ADDENDUM NUMBER 1

GATEWAY PARK

September 7, 2021

ENGINEERING PLANS FOR:
CITY OF CORCORAN GATEWAY PARK
 SHEET TITLE:
SOLAR LIGHT PLAN LAYOUT

SHEET NO.
CD-14.01

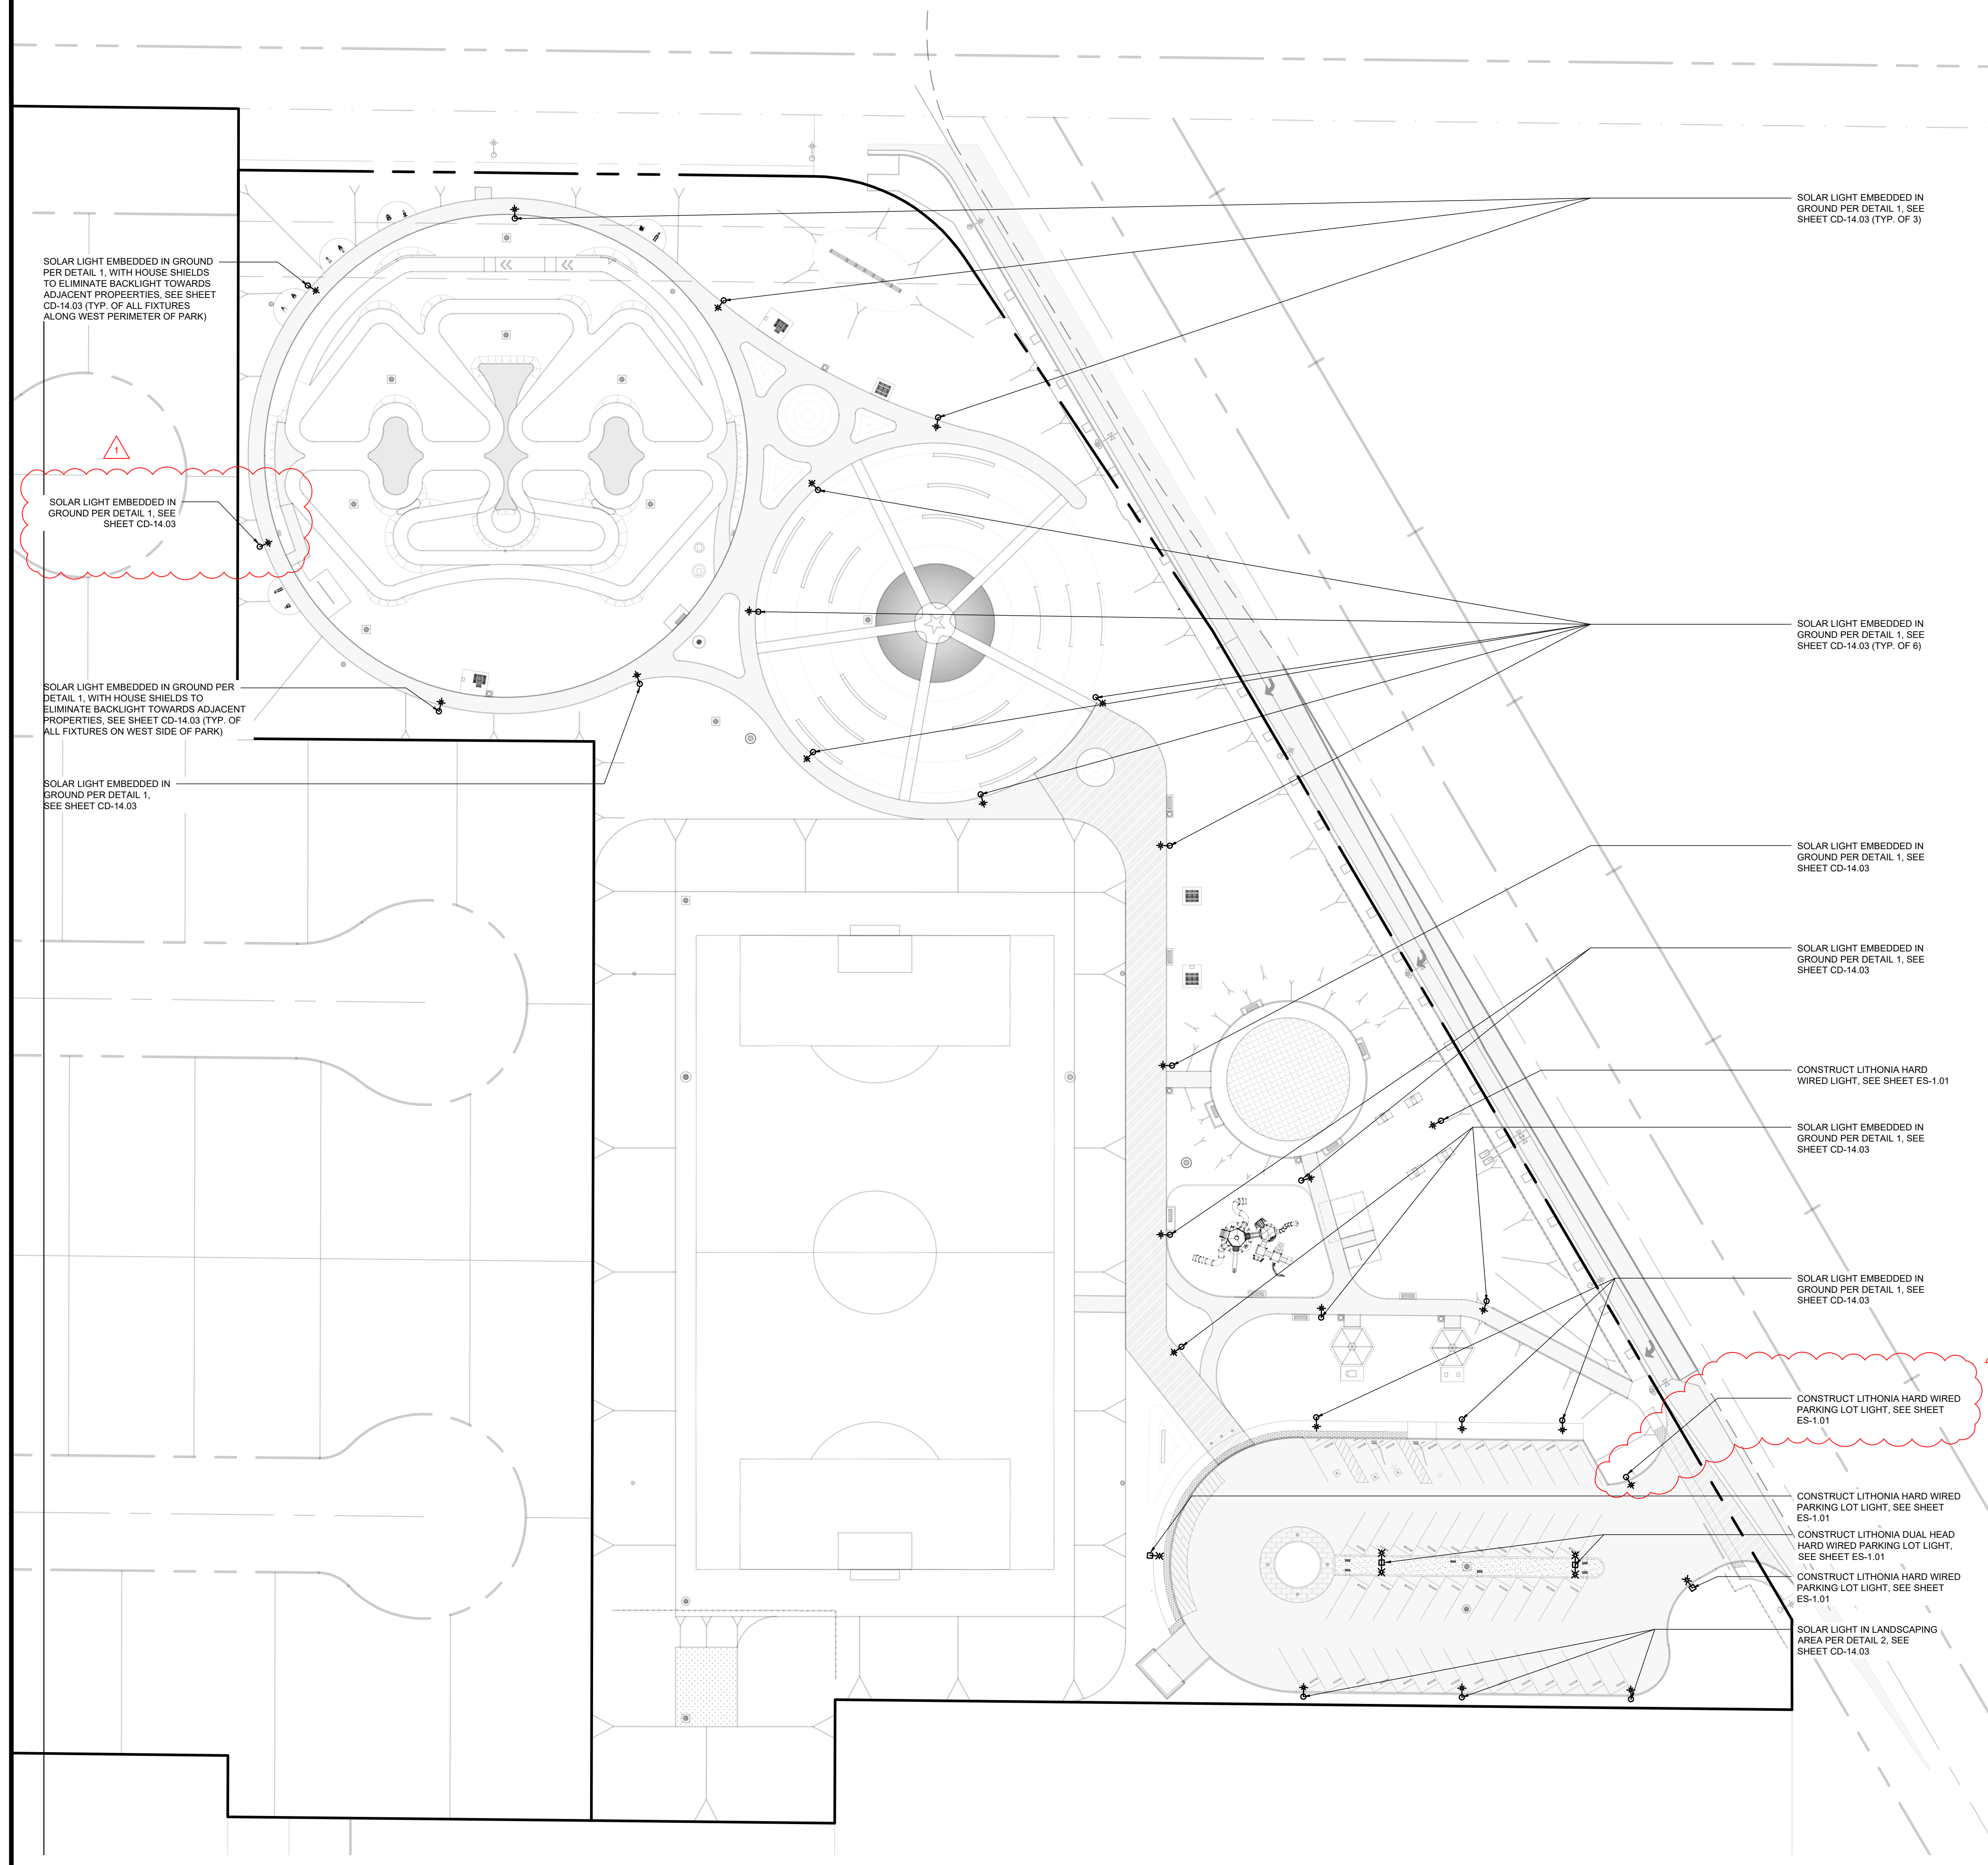
On sheet CD- 14.01 I counted 26 solar pole mounted light fixtures. Electrical drawing sheet ES-1.01 only shows 24 of the same light fixtures. Please advise as to which drawing sheet we should use to price this project.

Use a total of 25 solar mounted light fixtures as shown on the attached CD-14.01. Contractor shall coordinate electrical drawings with CD-14.01.
